AD/RHIC-AP-43

R.F. Accelerating Cavities for RHIC

MEMORANDUM

DATE: January 16, 1987
TO: E. B. Forsyth
FROM: J. G. Cottingham *JGC*
SUBJECT: R.F. Accelerating Cavities for RHIC

Fig 1

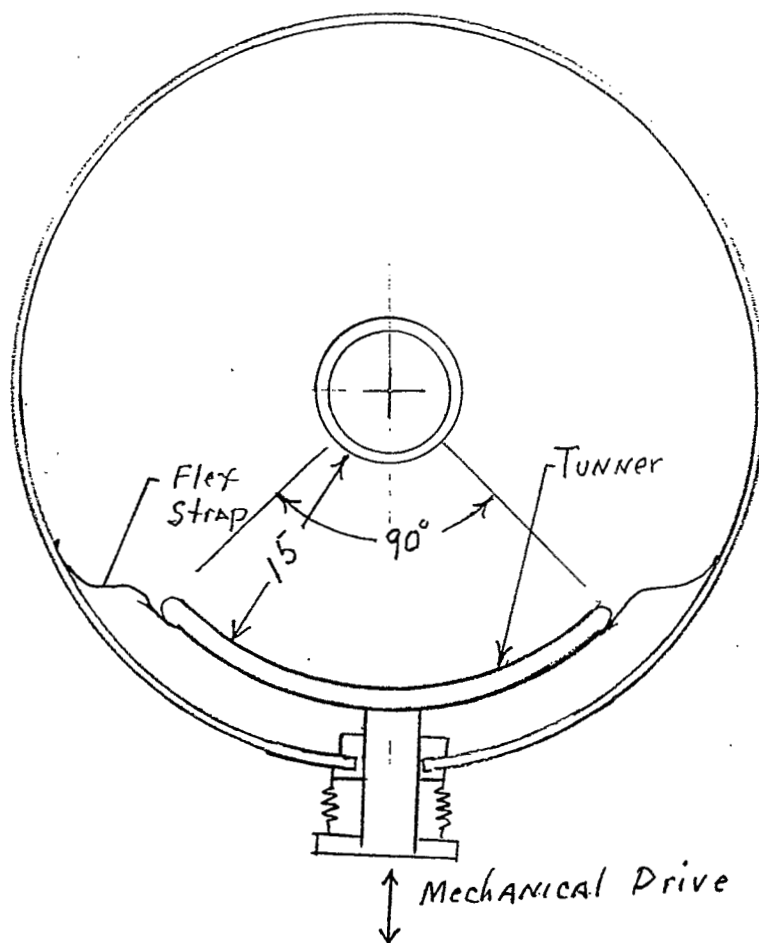
I have also reviewed the high voltage r. f. cavity design described by M. Puglisi in RHIC Technical Note No. 6. As you know this cavity design was the basis for the design presented in the RHIC Conceptual Design where it was modified to include a frequency tuning feature, (see page 241). The design is sound with one exception. I don't like using the accelerating gap spacing as a means of adjusting the frequency. I believe that stress flexure and motion should be avoided in this high gradient region. Instead I would suggest a "side" tuning plunger which I believe is more conventional. I have sketched a design of this type, (see attached Fig. 1).

This plunger is mechanically positioned by an external mechanism working through a bellows to accomplish the desired tuning. The electrical connection to the plunger is accomplished by flexible copper straps. Sliding r.f. joints in a vacuum is in my view a no-no. The required motion for normal operation is small, see attached tuning-position curve, but the full range requested in the Conceptual Design is available.
